**ADDENDUM NO. 2 TO
FINAL ENVIRONMENTAL IMPACT
REPORT**

**MOSQUITO ROAD BRIDGE
REPLACEMENT PROJECT**

October 2022

1. Staging Area and Batch Plant Location Map
2. Route to Syar Concrete Mixing Plant

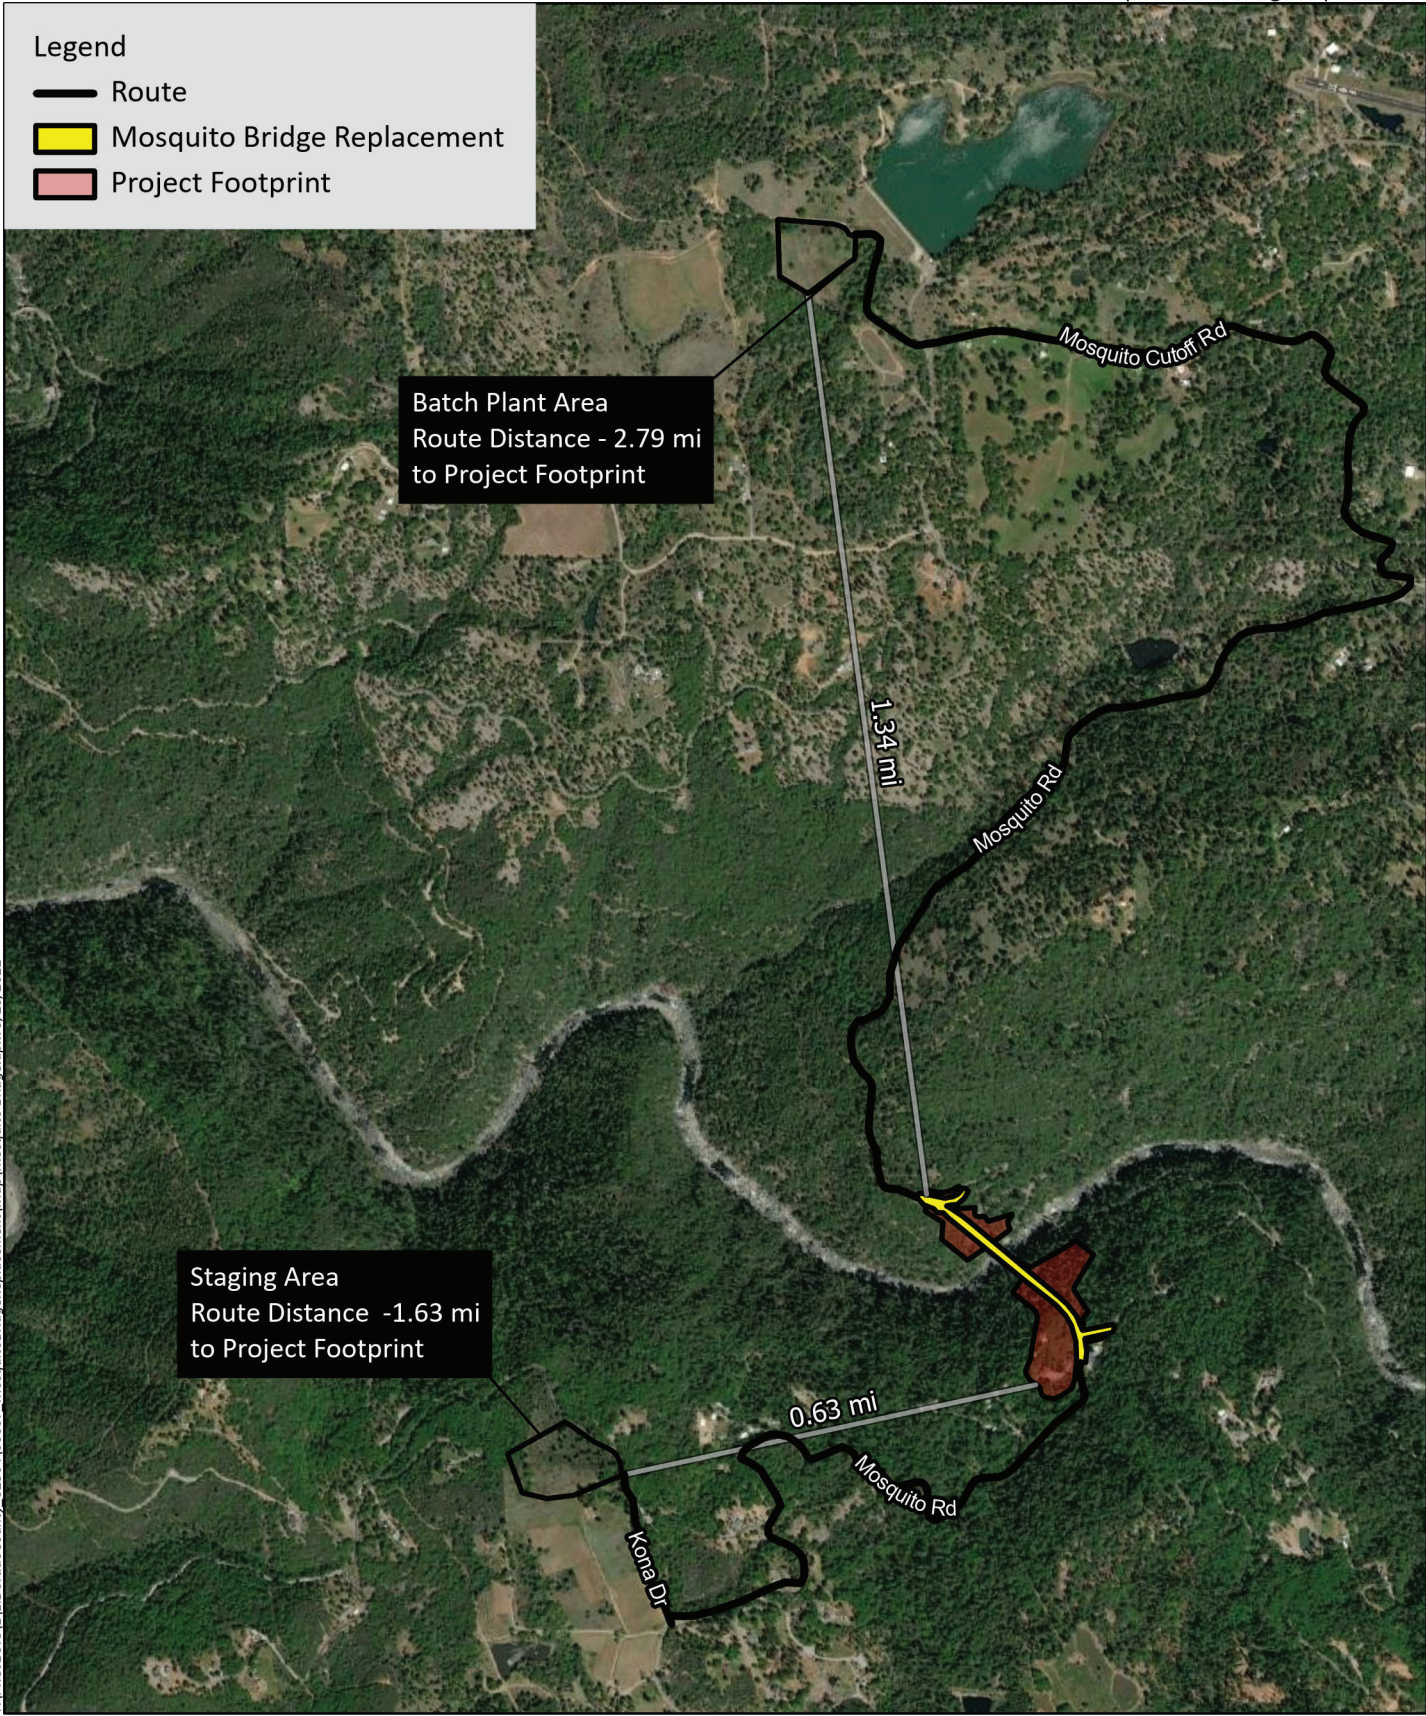
Therefore, the proposed construction plan would be revised to include the temporary siting of a concrete batch plant and construction equipment staging areas in locations that are sufficiently sized to support the project construction needs and are also in close proximity to the proposed Project site. The proposed concrete batch plant area is undeveloped, although two small entry points have been cleared of vegetation and rip rap has been placed. A large, flat gravel pad has been placed within the staging area, and all vegetation in the pad has been removed. The southern portion of the staging area is undeveloped. Both areas would be restored to the previous use after the temporary use during construction is complete and reseeded as necessary. The proposed concrete batch plant and staging areas encompass approximately 14 acres. See Figure 1 which shows the locations of the two areas in relation to the Project site.

Route to Syar Concrete Mixing Plant

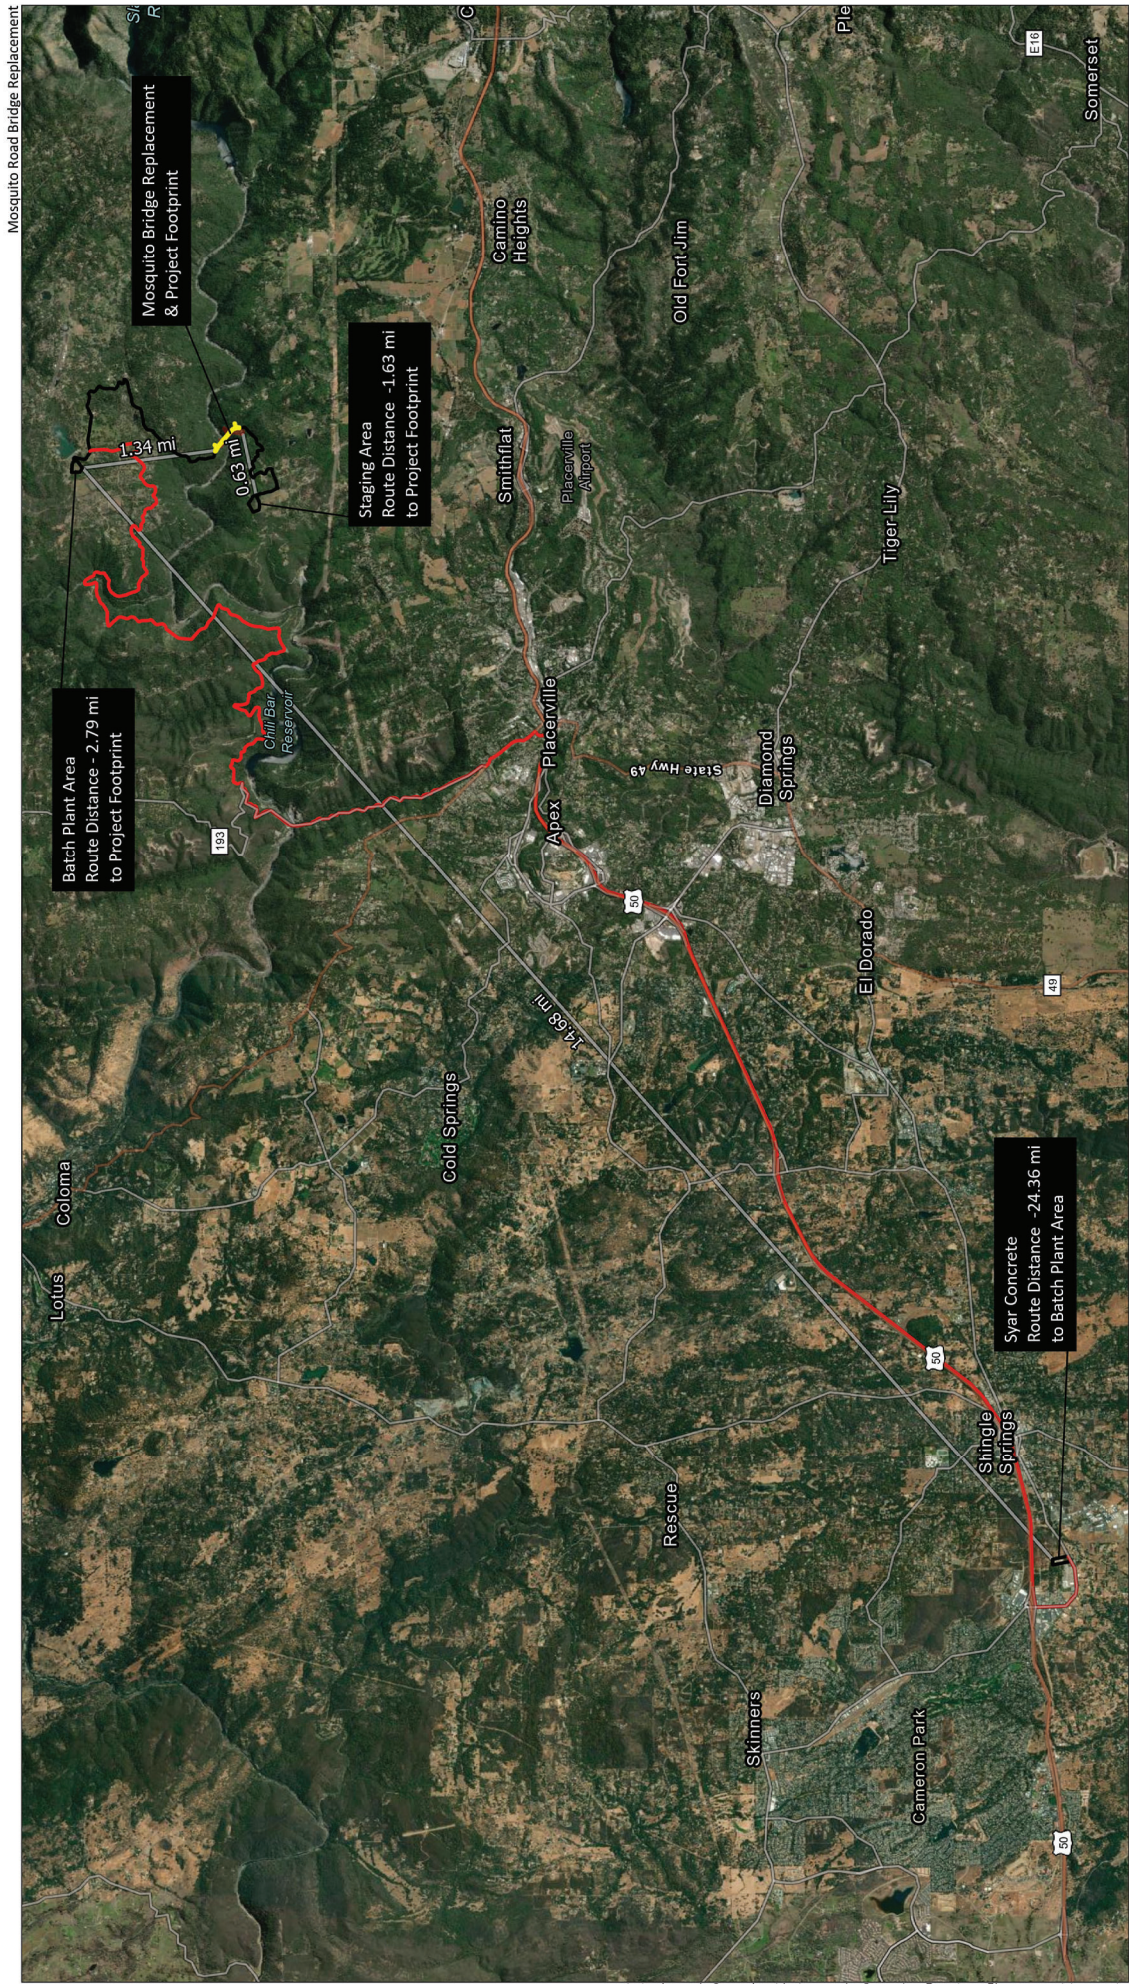
As noted above, the siting of a concrete batch plant near the proposed Project would substantially reduce truck trip distances associated with the original construction plan to transport concrete from the Syar Concrete plant to the Project site. According to the Senior Civil Engineer, Brian Franklin, of El Dorado County Department of Transportation, if the concrete is not supplied by the batch plant proposed near the Project site, it would be supplied by the Syar Concrete plant. The route for the concrete trucks would be via Hwy 50 to Hwy 49 to Hwy 194 to Rock Creek Road to Mosquito Road to the batch plant site. As the route would pass adjacent to the proposed batch plant site, the route from the batch plant site adjacent to Rock Creek Road to the Project would be the same. Based on a Google search for the distances, it is approximately 24.36 miles from Syar Concrete at Shingle Springs to the proposed batch plant location and an additional 2.79 miles to the site, totaling approximately 27 miles. This project construction change would provide a reduction of approximately 54 Vehicle Miles Travelled (VMT) per truck load. See Figure 2 which shows the batch plant location in relation to the Syar concrete plant.
